Equity Response 2017-0117 to Staff's January 12th Comments

WESTWOOD SHOPPING CENTER

SKETCH PLAN

SK8

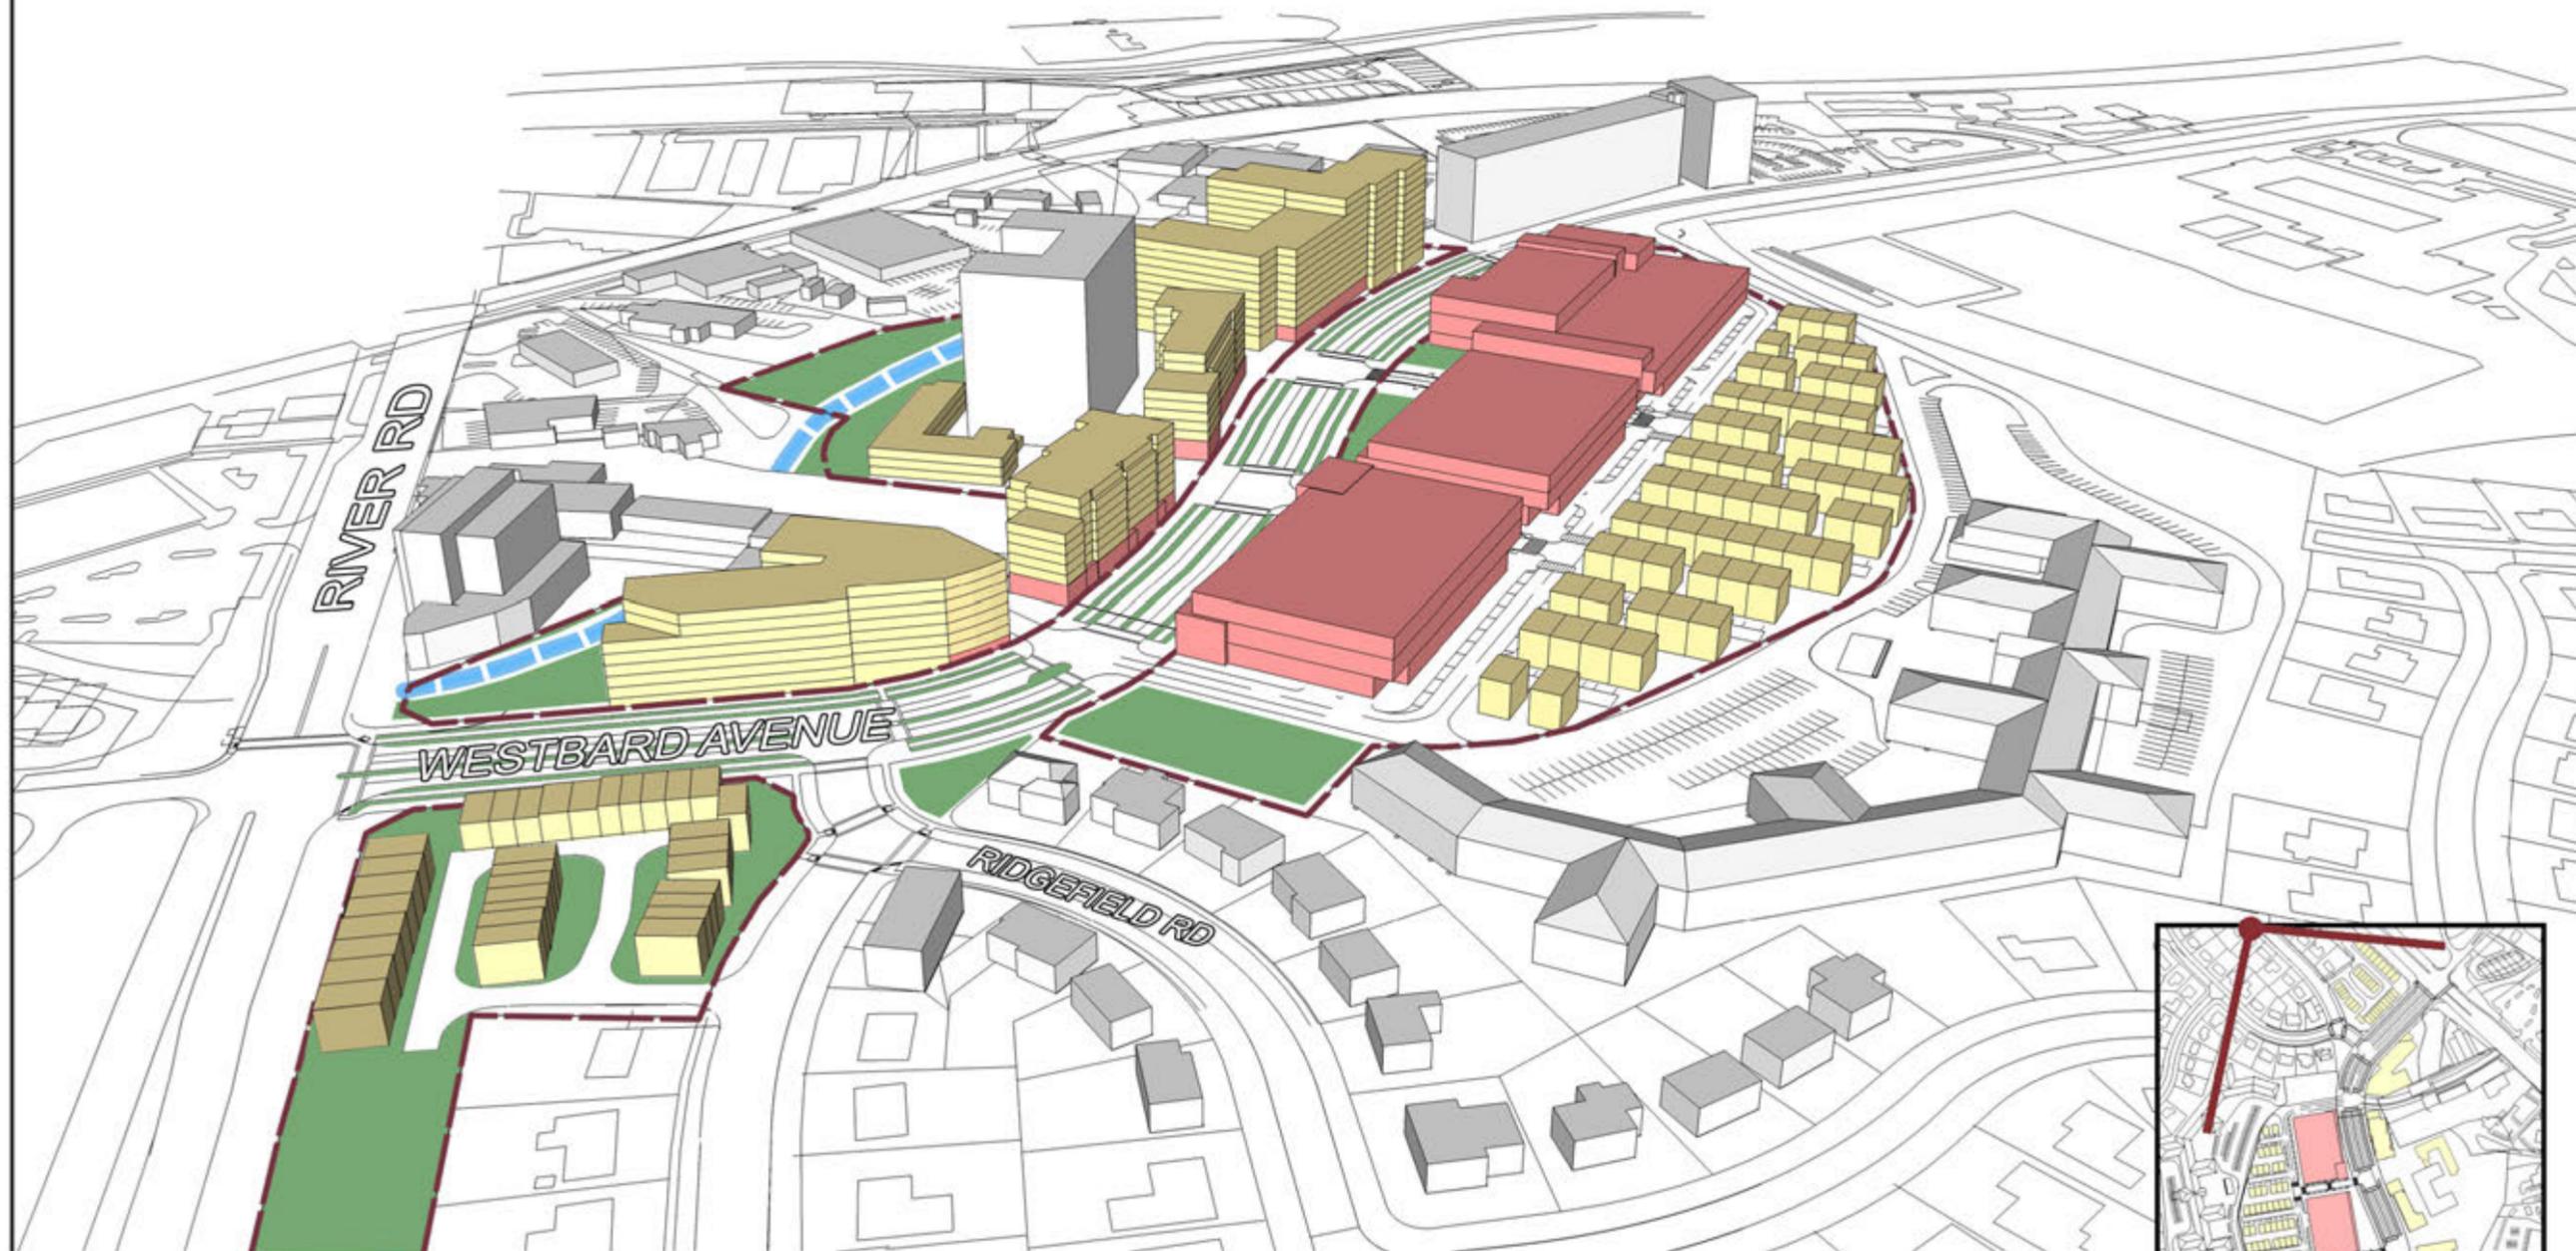
<p>29. SK 8 and SK 9 should show green on the other side of the</p>	<p>29. See revised SK8 and SK9.</p>

stream behind the HOC building.	
30. At the Bowlmor site, shift proposed building off the steep slopes and far enough to provide clearance for a 20'-minimum width of access easement (to be granted to M-NCPPC).	30. See revised plans with the revised footprint, which has had a 20' width reduction (SK2 and SK16).

SK10

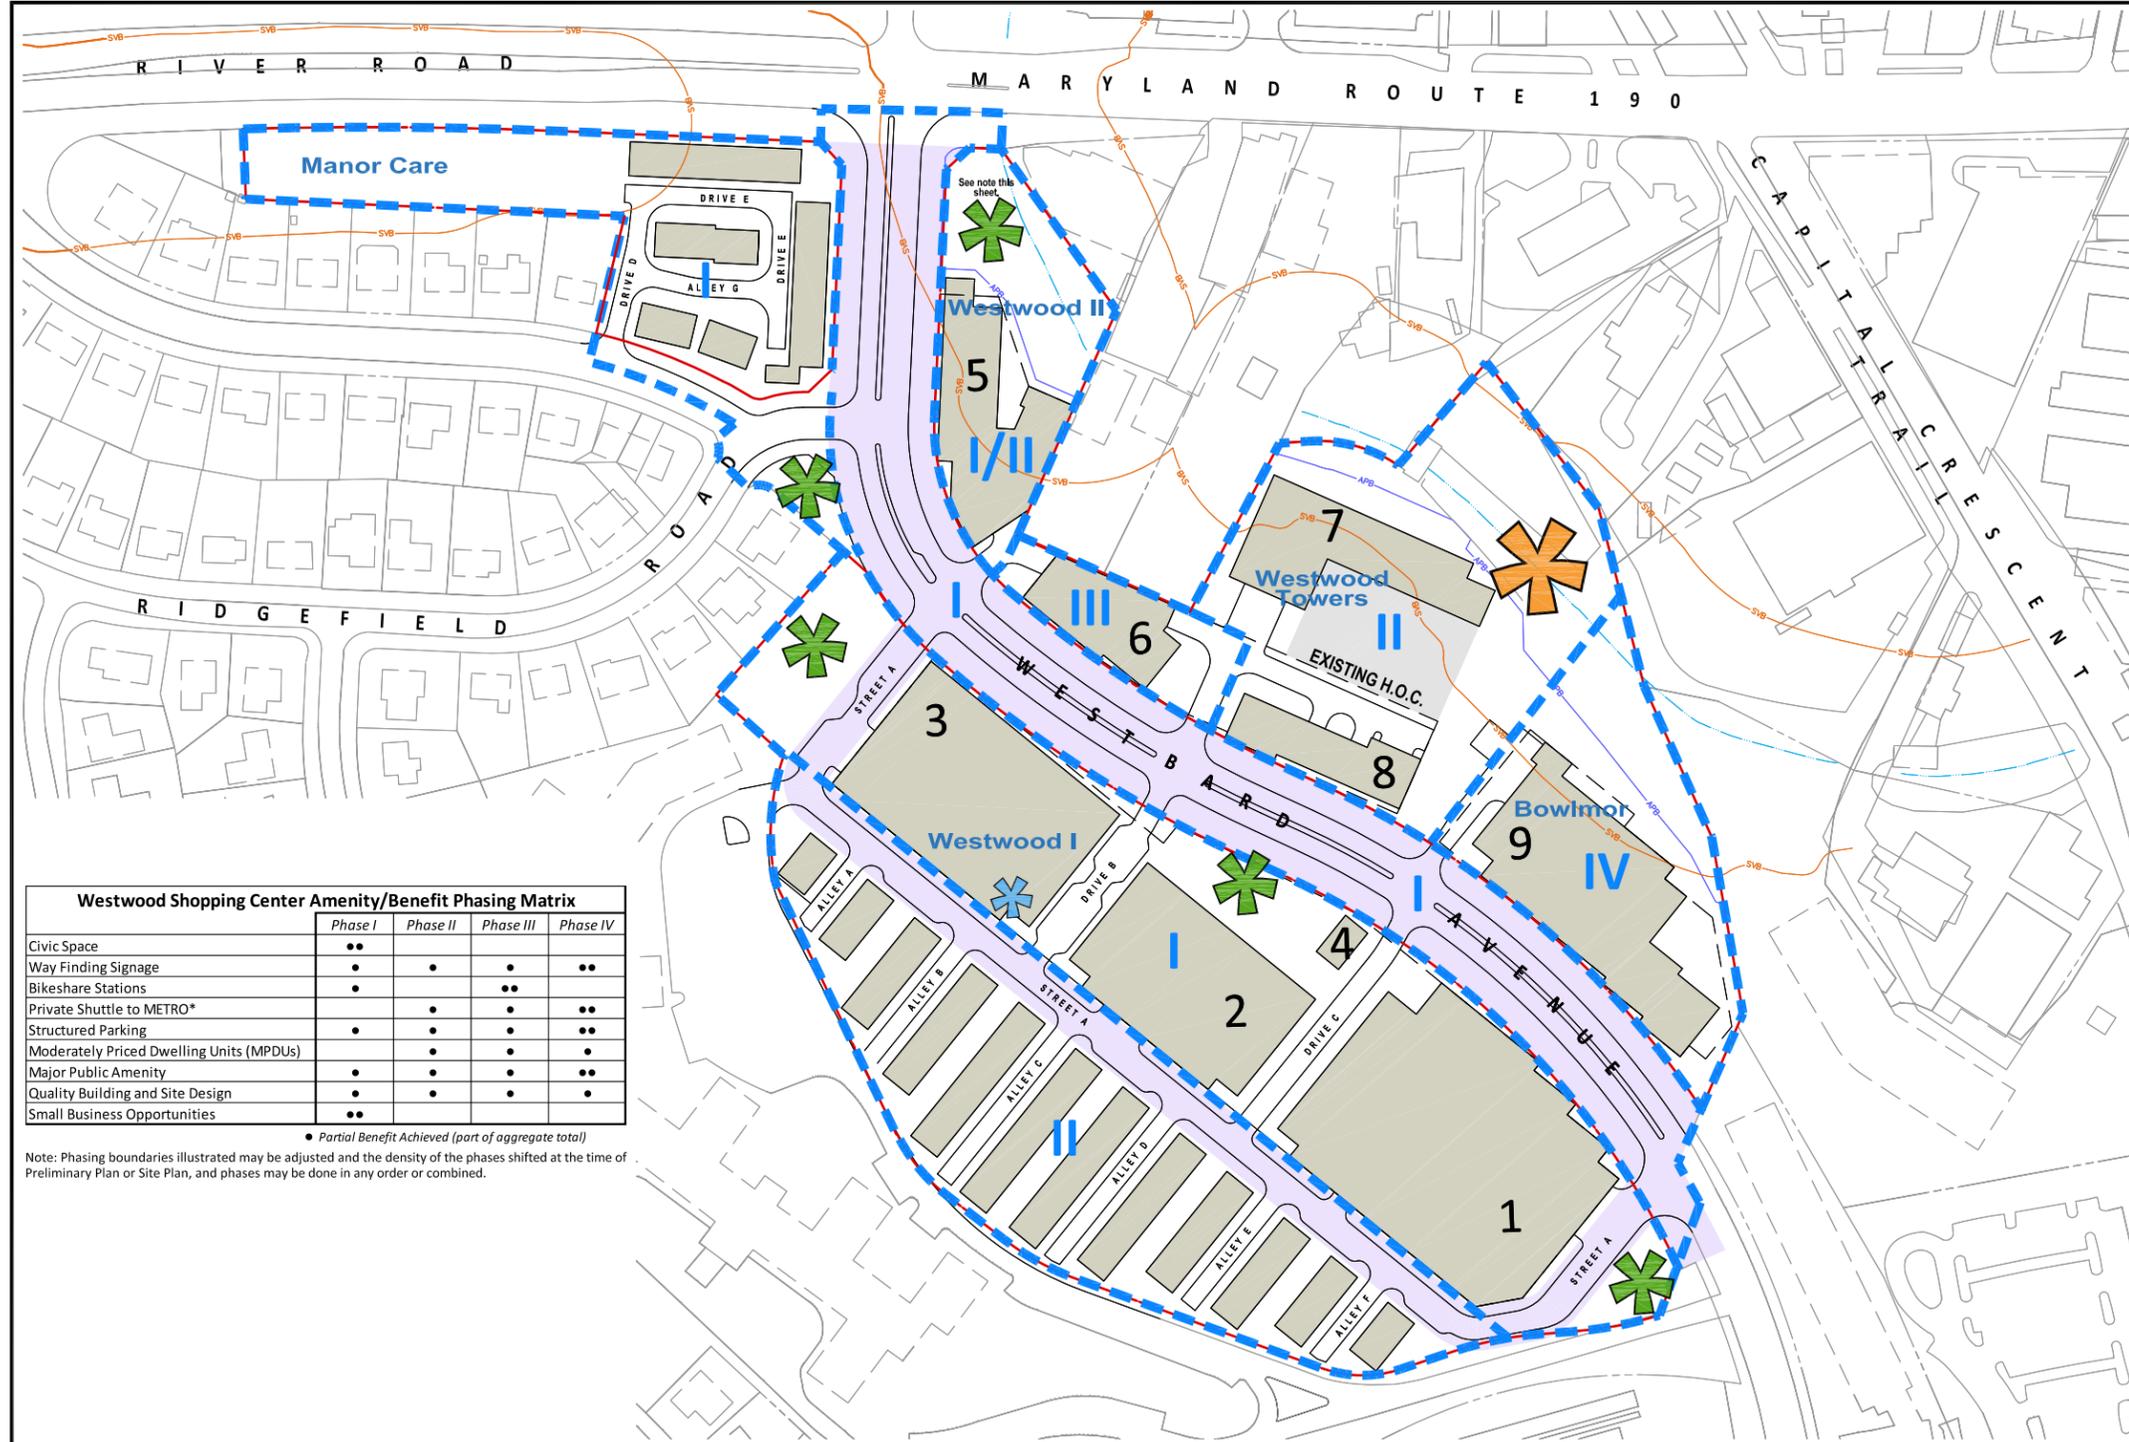
<p>25. On SK 2 and SK 10, please add an additional star behind HOC or move and enlarge the existing orange star behind the Bowlmor site so that the star/s better represent the extent of the greenway behind those buildings.</p>	<p>25. See revised SK2 and SK10. The star has been enlarged and moved more centrally.</p>
<p>26. The final resubmittal should recommend specific steps once the results of the archeological investigation is completed.</p>	<p>26. Per our discussion, details of the archeological investigation will be addressed at Preliminary Plan.</p>
<p>27. If the garage attached to the HOC building is accepted it needs to show a proposed height on sheet SK2. The way it is currently portrayed it could go to 165 feet. It needs a circle with proposed numbers.</p>	<p>27. See revised SK2. A proposed maximum height of 70 feet has been added to this element.</p>
<p>28. On SK 3 the Applicant's Proposed Dedication Line behind HOC appears too far from the proposed building based on previous discussions between staff and the Applicant.</p>	<p>28. The line has remained as it was, but the building has gotten thinner, to allow for SWM facilities on the lot.</p>

SHEET No:
SK16
320170010

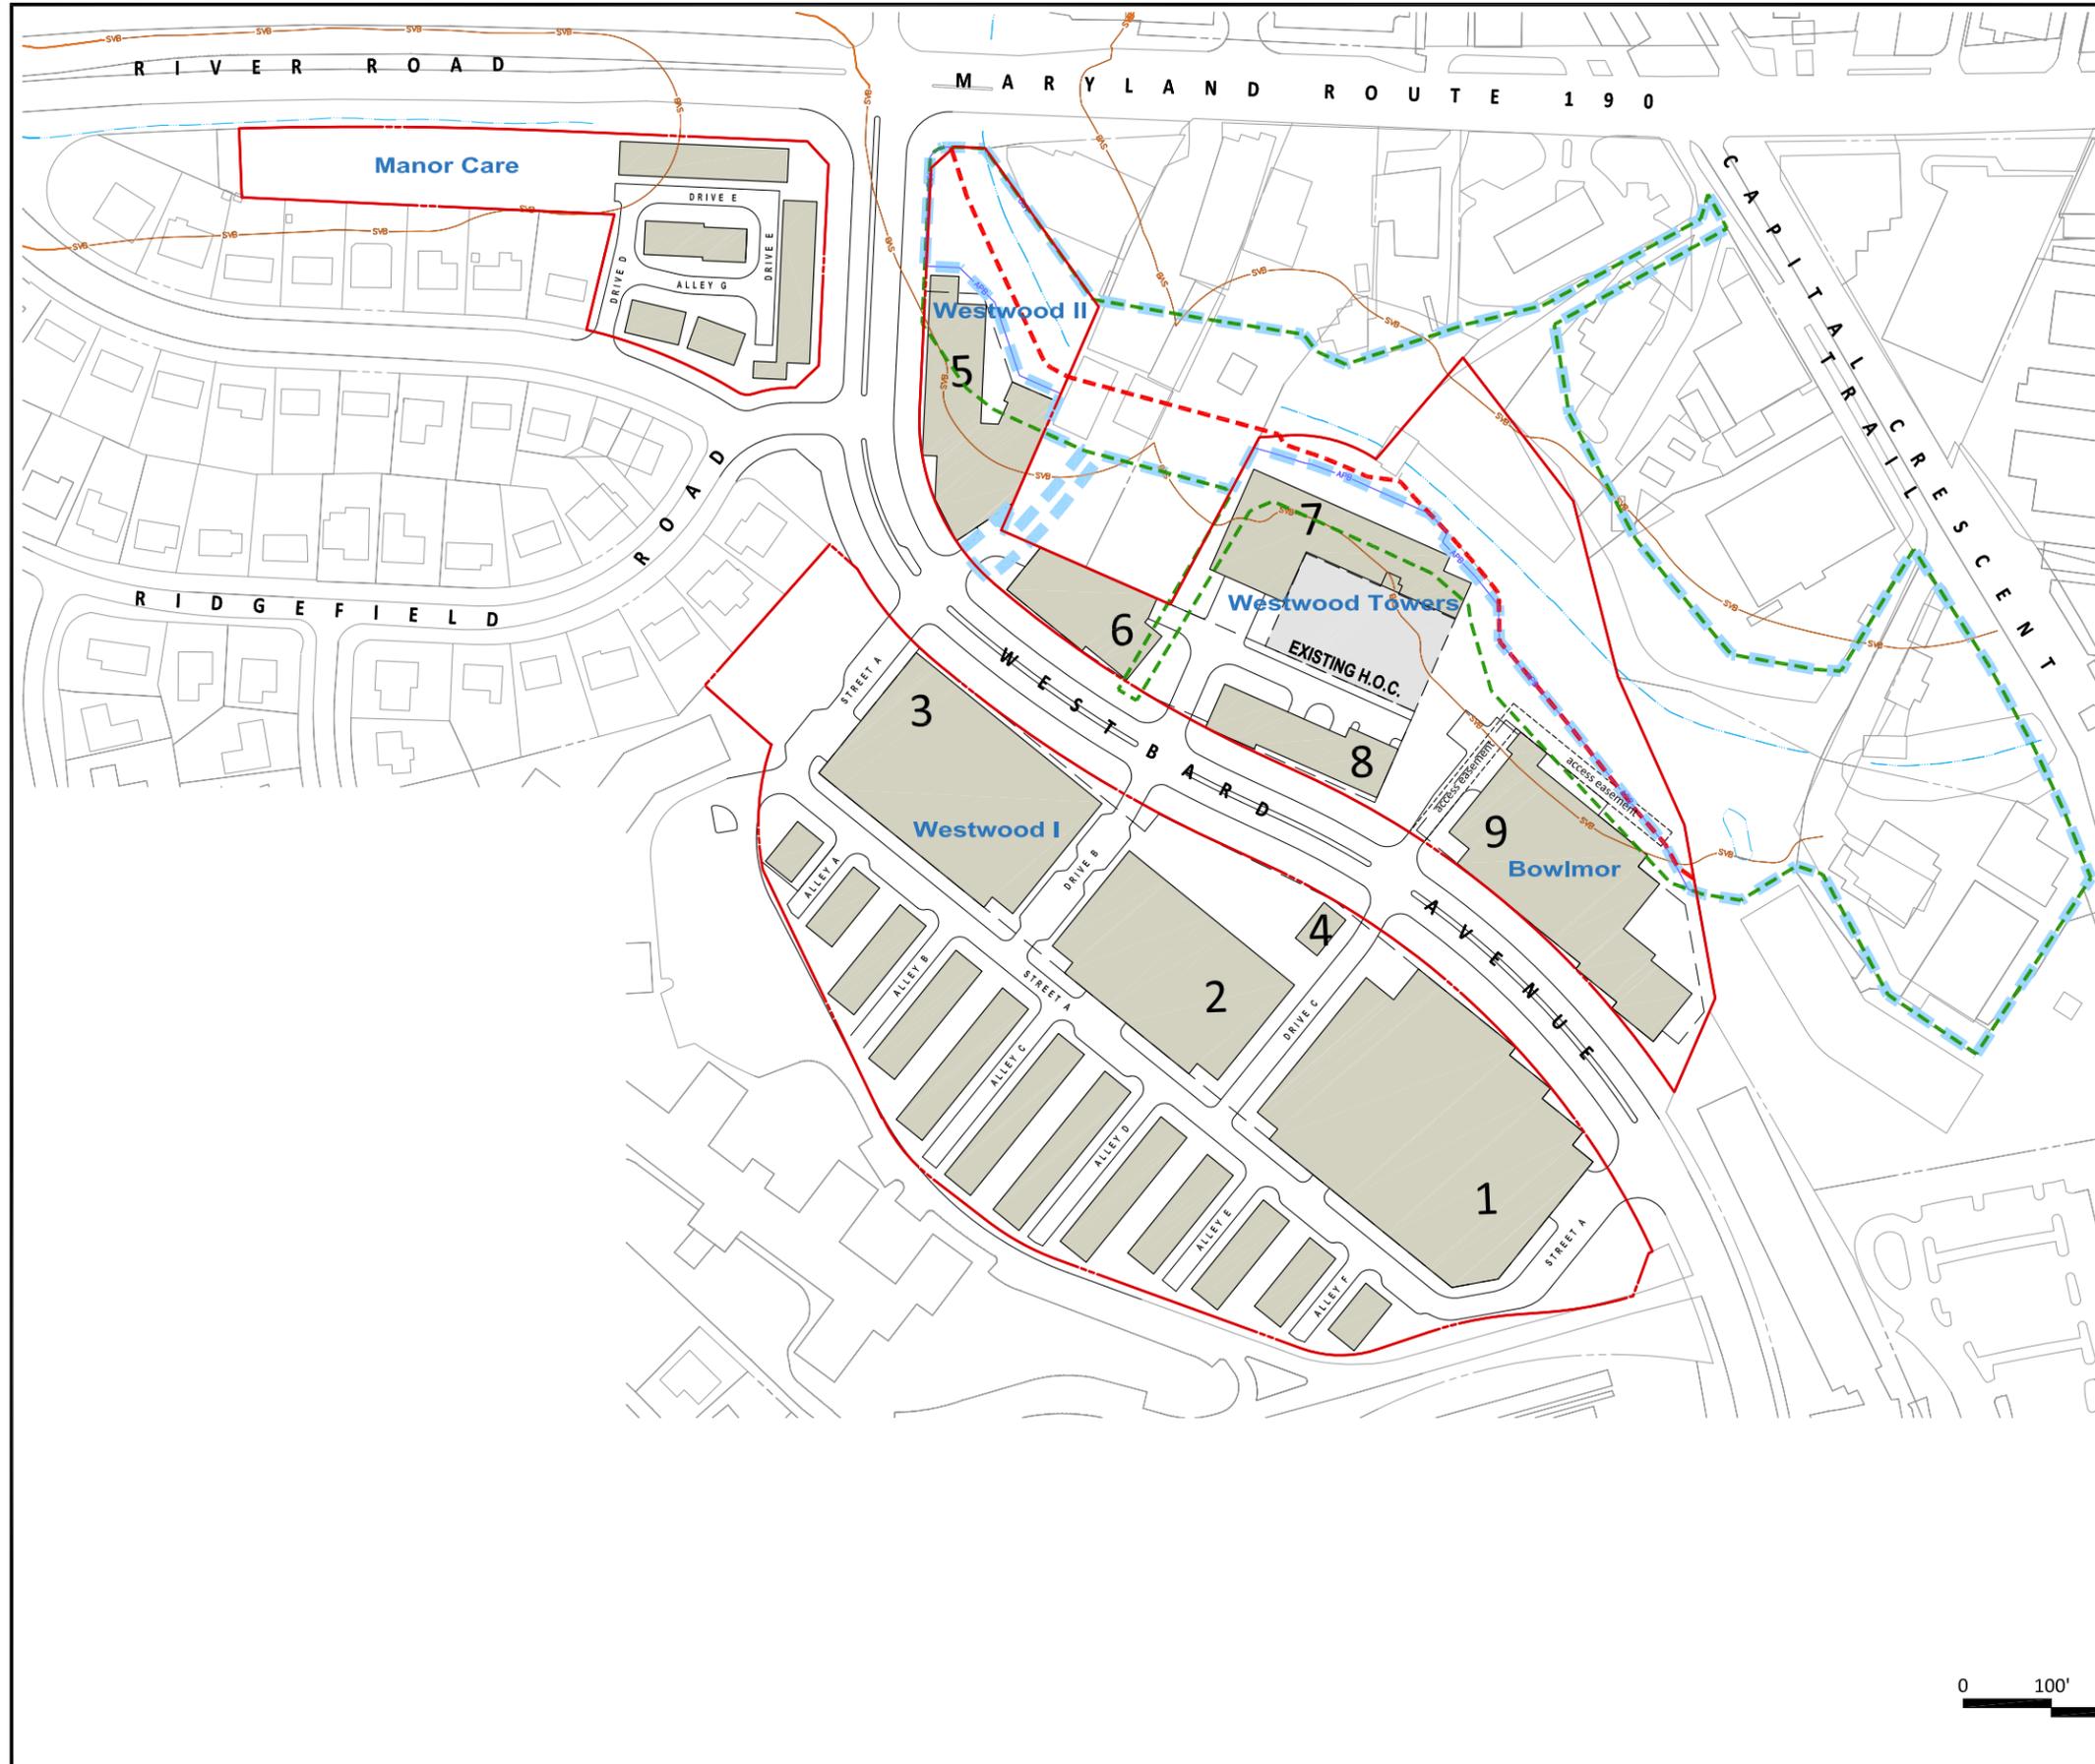
<p>7. On page 2 of the narrative, the Willett Branch is not included in the Public Benefits table, however, it is included and described in the Public Benefits table and narrative on page 16. Thank you for including this in the public benefits and recognizing the importance of the Willett Branch as a major public facility and amenity in the Sketch Plan. Staff will continue to discuss the Applicant’s contributions toward the Willett Branch.</p>	<p>7. The estimated dedication has now been added to page 2 of the Justification Statement.</p>
<p>8. Include the exhibit of the Staffs proposed dedication line (“Andy Line”)/Applicants Proposed Dedication line as part of the formal sketch plan submission. The document is critical in memorializing the ongoing discussions and compromises for the ultimate park dedication. The formal exhibit is necessary for Staff to appropriately review the sketch plan application and ensure the Parks/Environmental/Sector Plan expectations can be achieved. (Conditions of approval and/or further comments maybe recommended/issued once the formal updated submission is received).</p>	<p>8. See revised exhibit SK16 included with this submission.</p>

LA 3.0
320170010

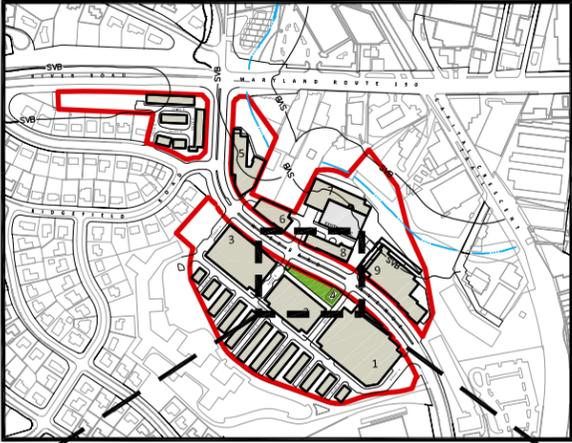
5. On sheet LA 3.0, please reference the design precedent examples and provide an example that includes programming.	5. Sheet LA 3.0 has been updated to address this comment.
